ANN ARBOR HISTORIC DISTRICT COMMISSION

Staff Report

ADDRESS: 321 E Ann Street, Application Number HDC24-0078

APPLICATION: The applicant seeks HDC approval to replace a non-original front stoop with a new roofed entry porch.

EXISTING PORCH PLAN

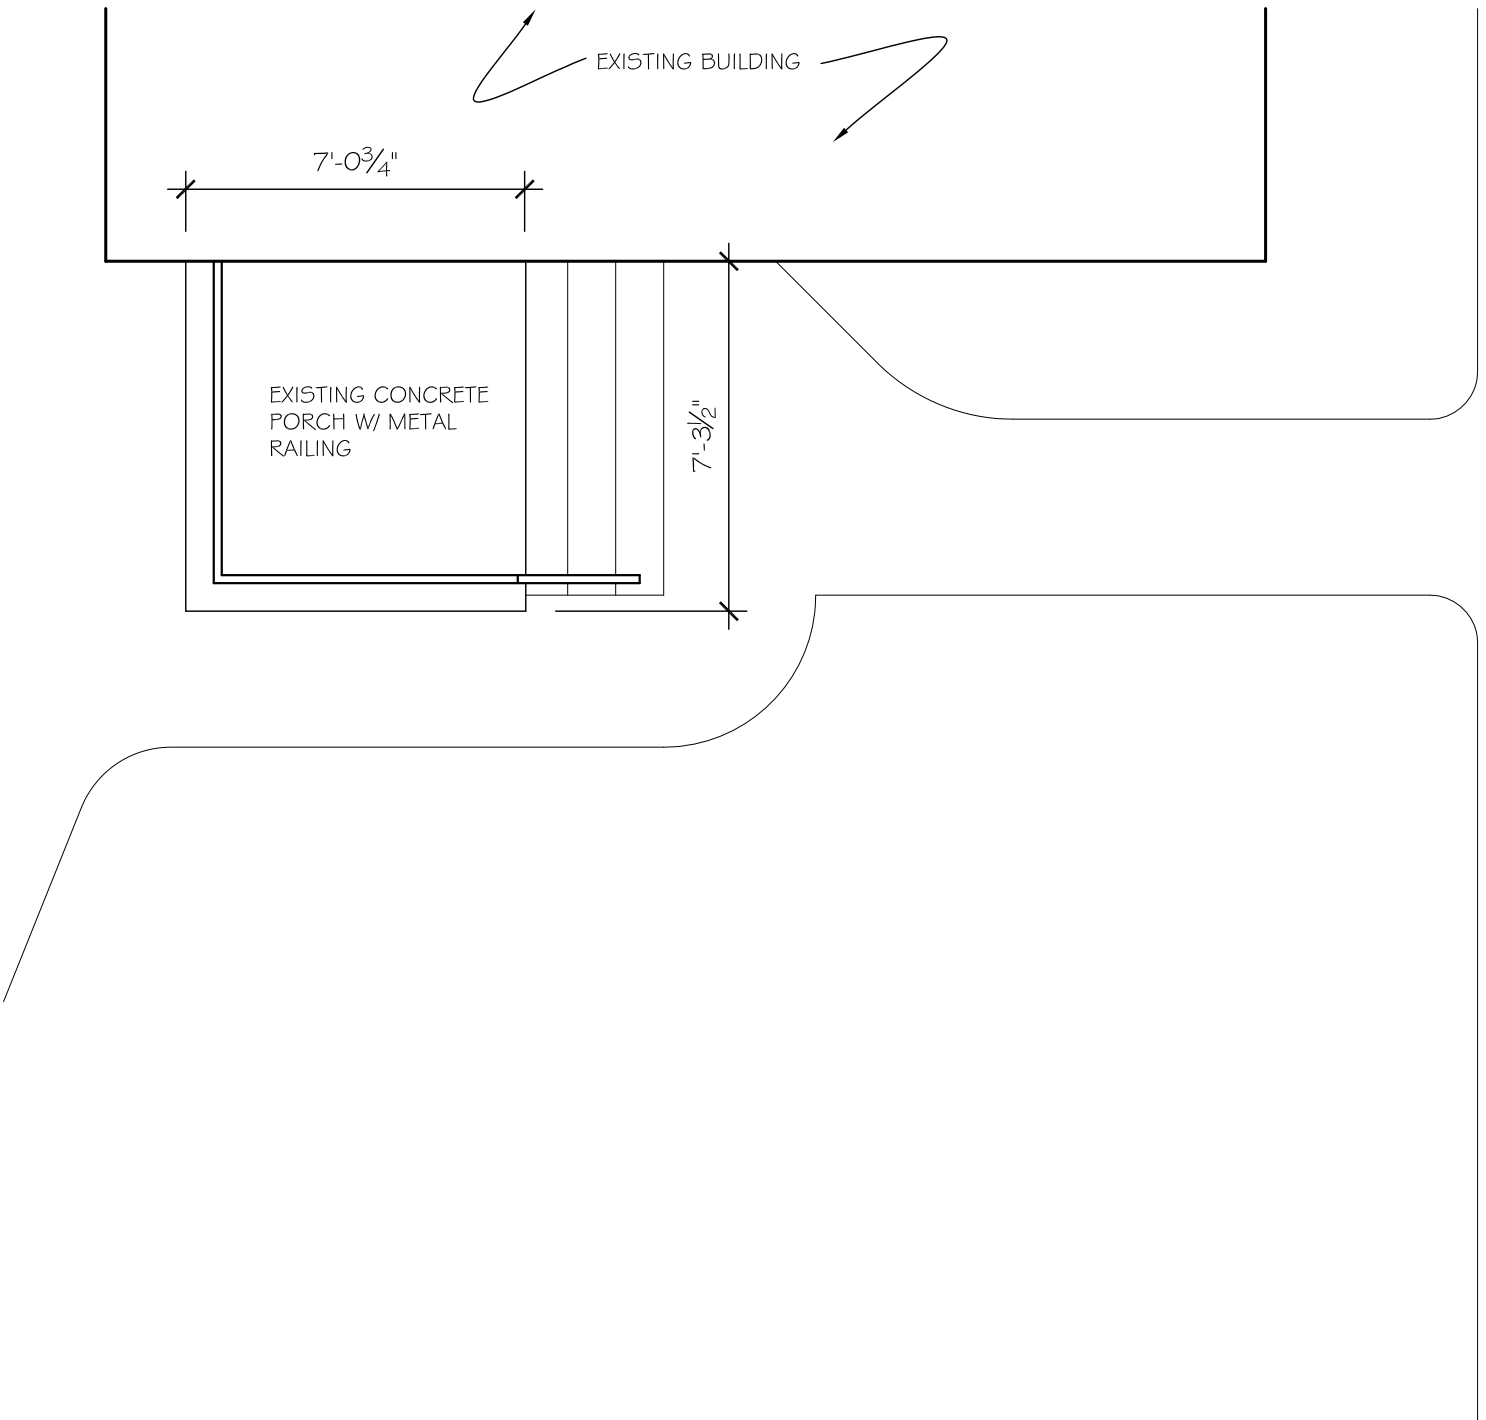
1. The house currently has an approximately 7' square concrete stoop with four east-side-entry concrete stairs and a metal guardrail. Per the 1931 Sanborn Fire Insurance Map, the house had a full-width front porch. That porch is present on 1947 aerial photos but was removed by 1960.

PROPOSED PORCH PLAN

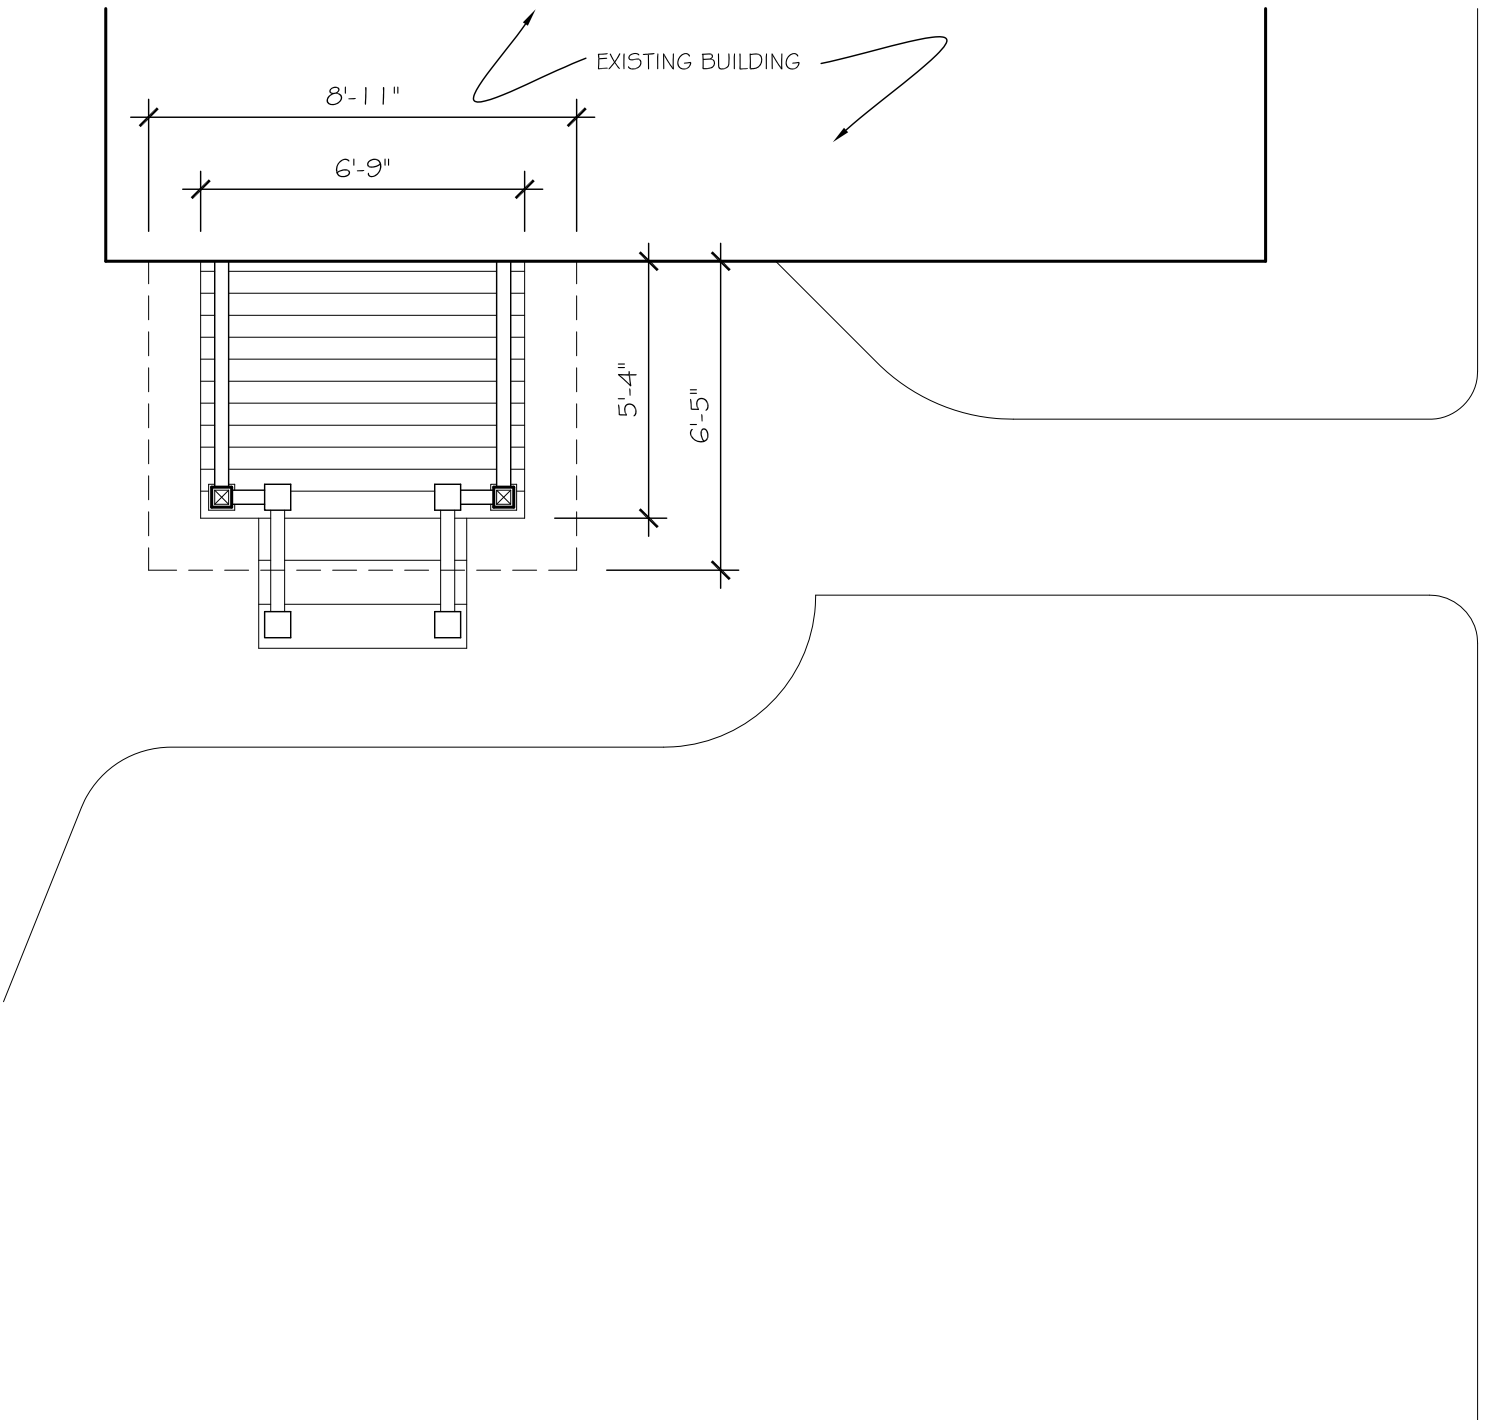
2. The proposed front porch is wood with a 6'9" wide by 5'5" deep deck, front facing stairs, two 5" square posts and a hip roof. Guardrails meet the HDC Design Guidelines, with a traditional design and height but extensions on top to meet Building Code height requirements. Skirting is painted wood lattice, moldings and trim are simple and traditional, and small brackets at the post tops give the porch some visual interest.

3. There are no changes to the existing concrete walk.
4. The porch was originally the full width of the house. This would be a more historically accurate reconstruction, but we don't know what that original porch looked like so at this time historic replication isn't an option. Replacing the existing concrete stoop with a covered wood porch is appropriate and will be visually compatible with the house. The design uses elements like straight porch posts and parallel (to the house) deck boards that won't be mistaken for historic but presents them in a way that is stylish and consistent with the historic rhythm of the block. Staff recommends approval.
